**ADDENDUM NO. 2**  
**Woodruff Landfill: Phase 7 Expansion Construction (Rebid)**  
**Transylvania County, North Carolina**

SUBJECT: ADDENDUM NO. 2 dated March 27, 2025, to the Contract Documents for the Woodruff Landfill – Phase 7 Expansion Construction (Rebid), dated February 21, 2025.

**CP-10**

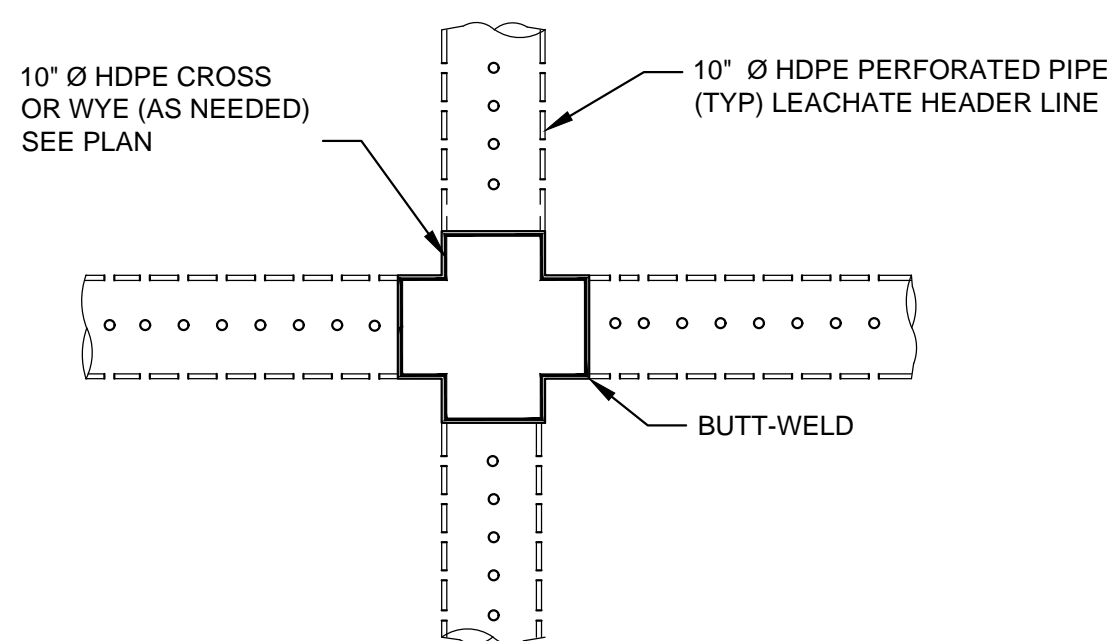
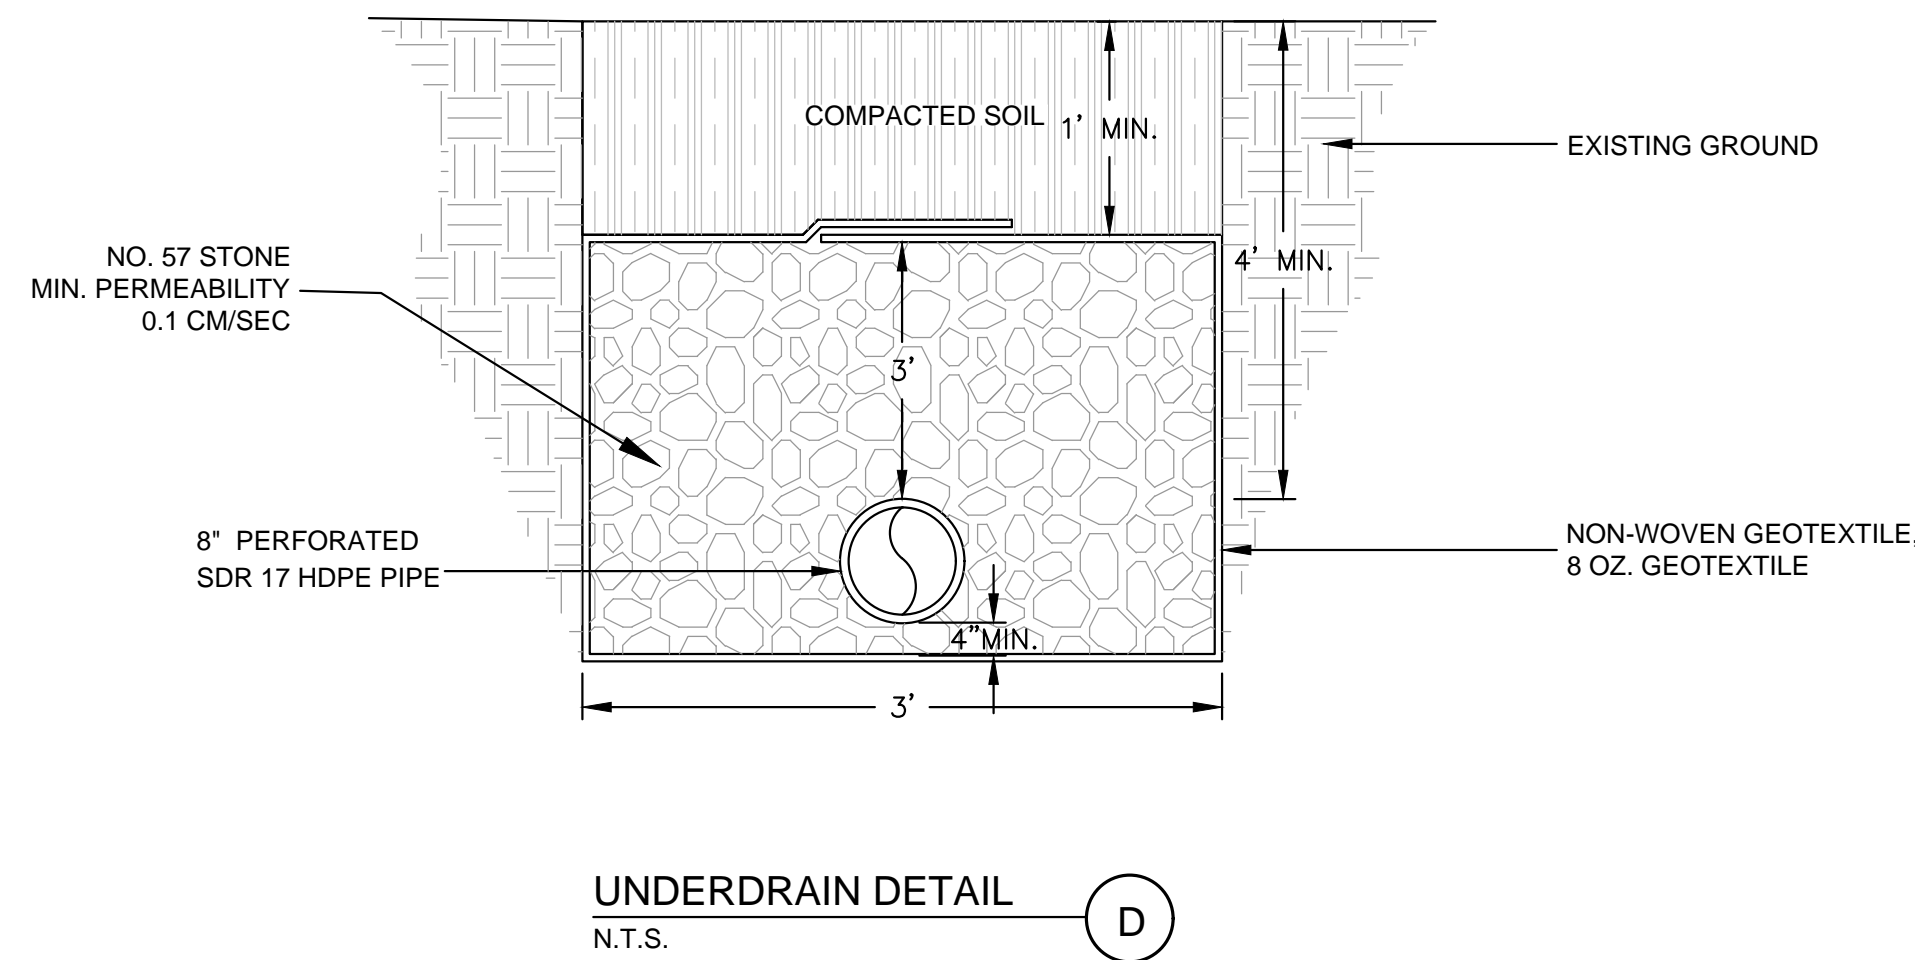
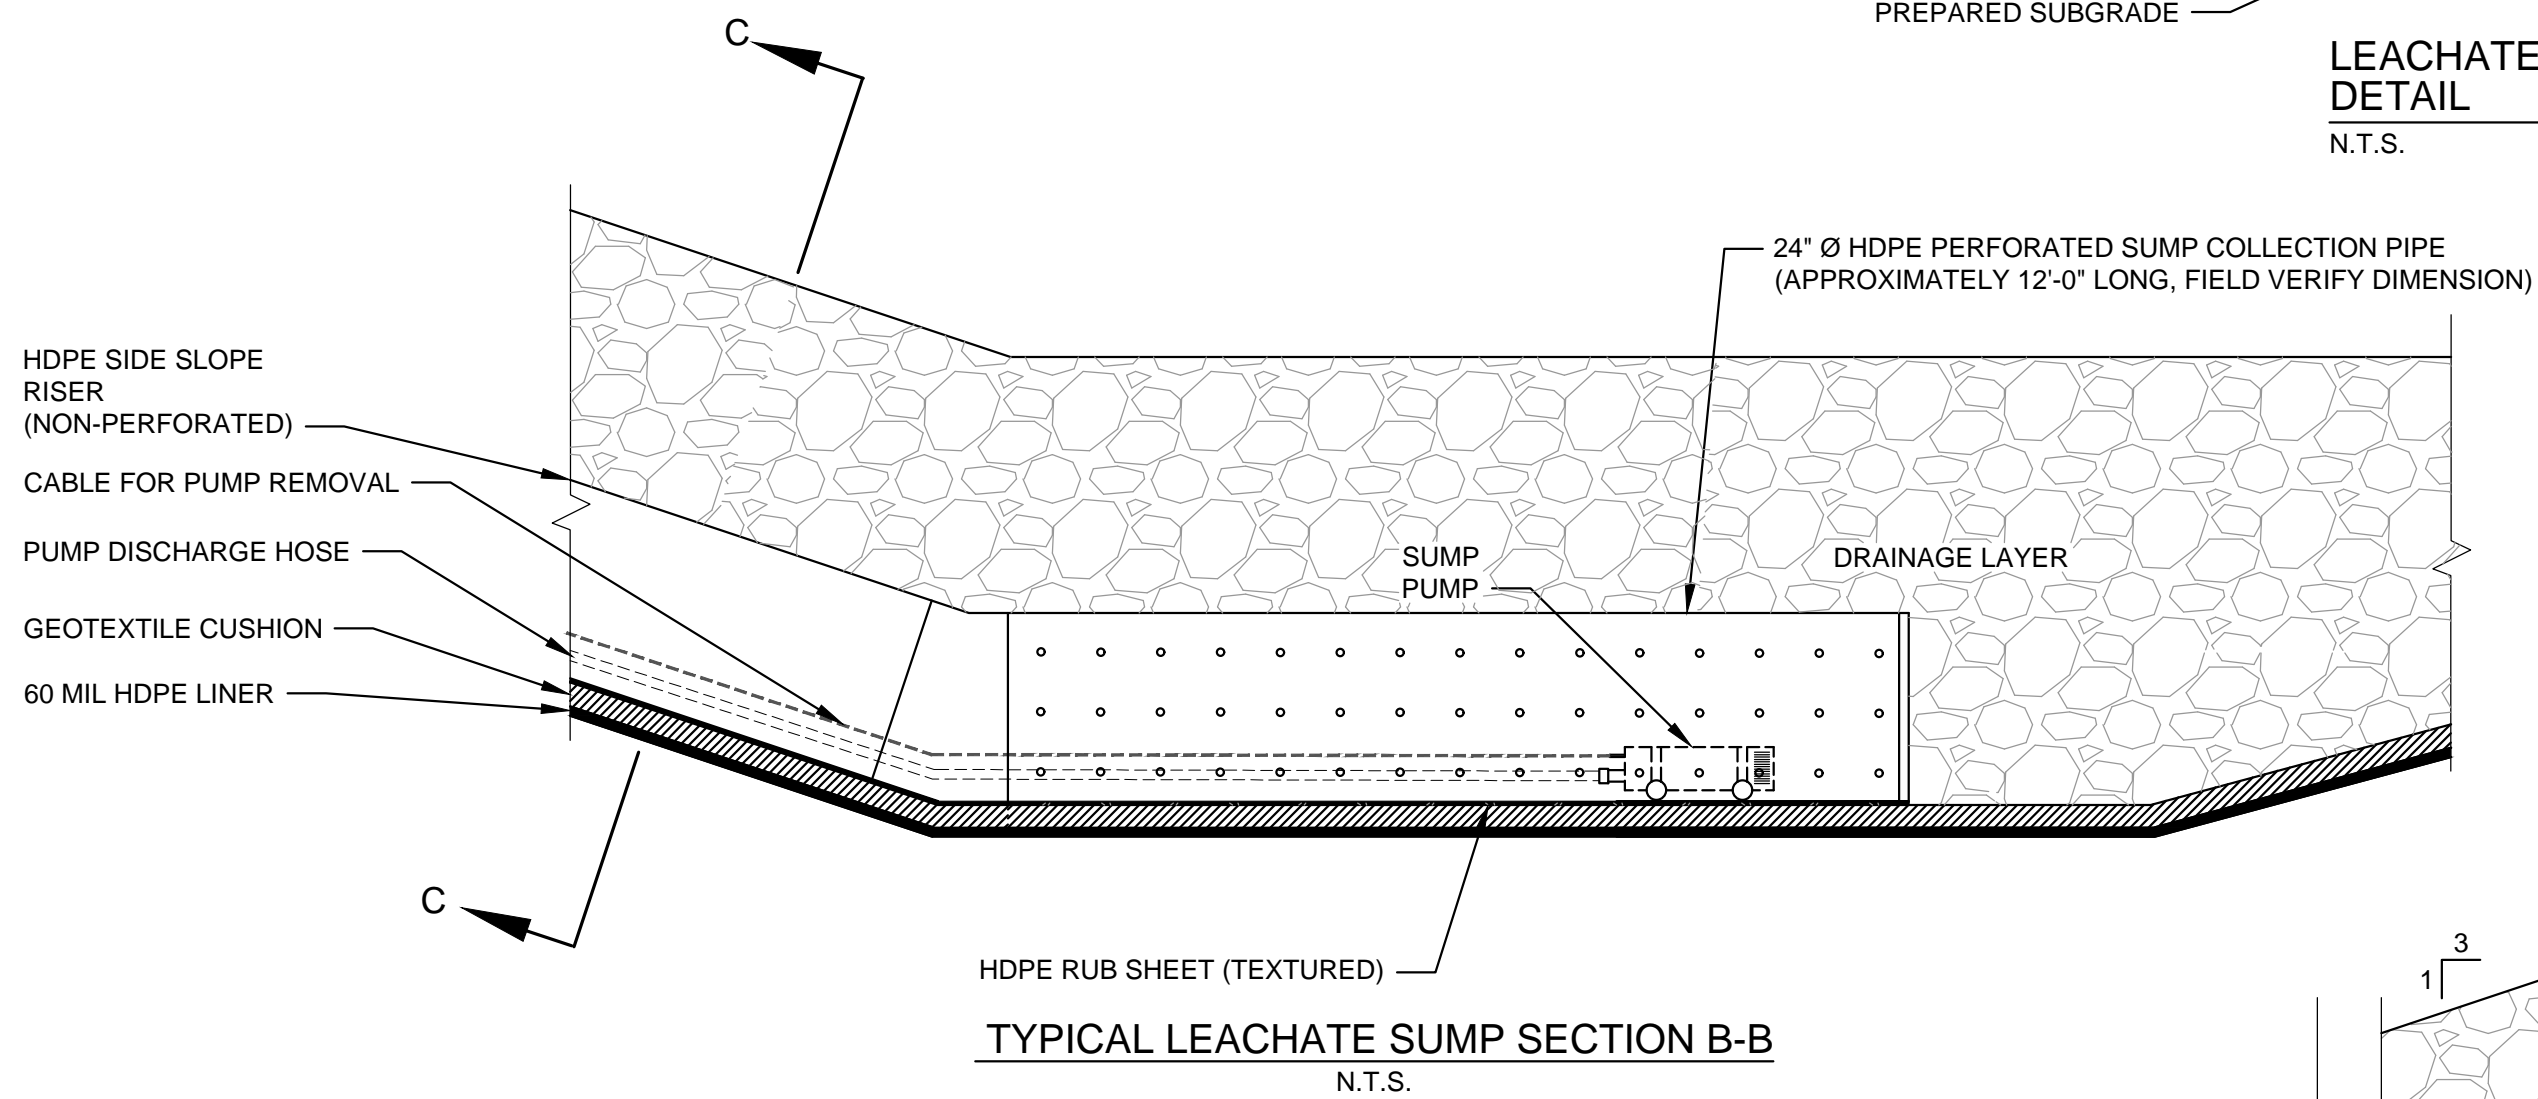
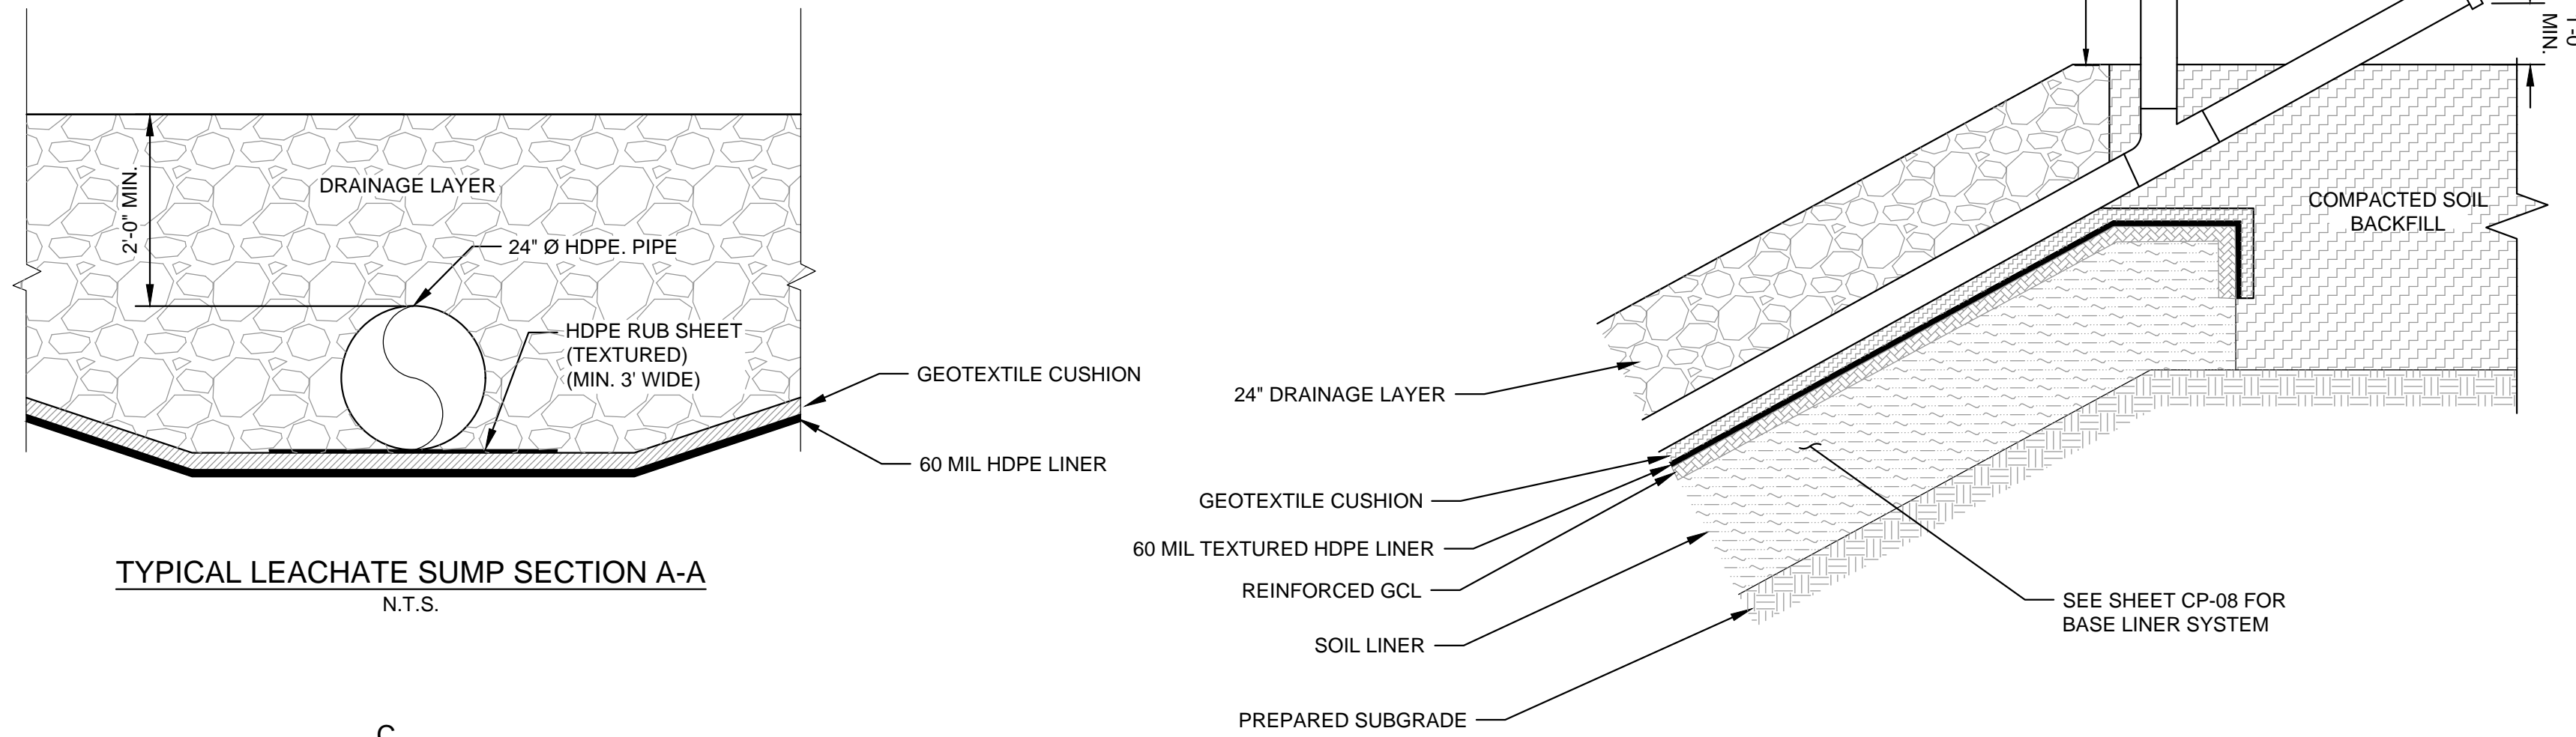
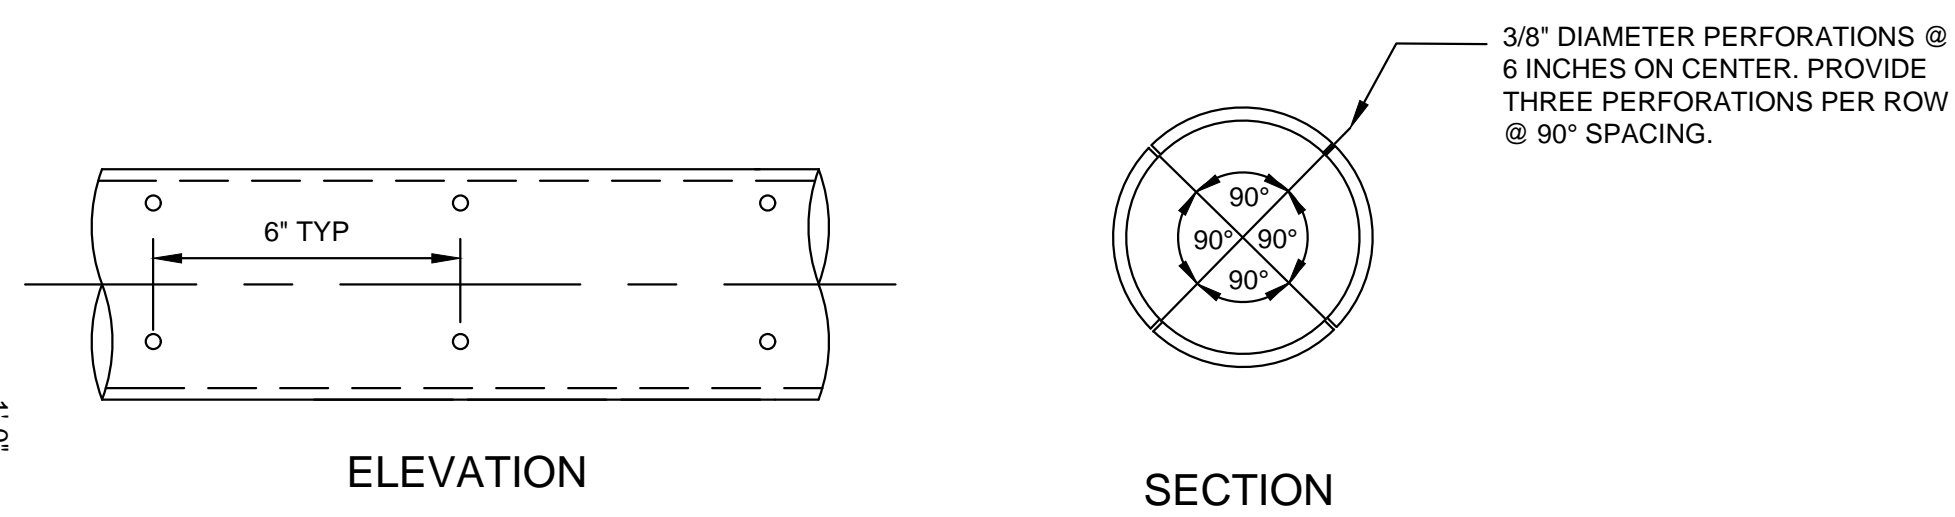
- Q.25 Are there any further details regarding the 6" Drainpipe to Landfill shown on Sheet CP-10, Detail C?
- A.25 The 6" drainpipe is an approximately 40' long solid HDPE SDR17 pipe that drains back to the Phase 7 sump area.
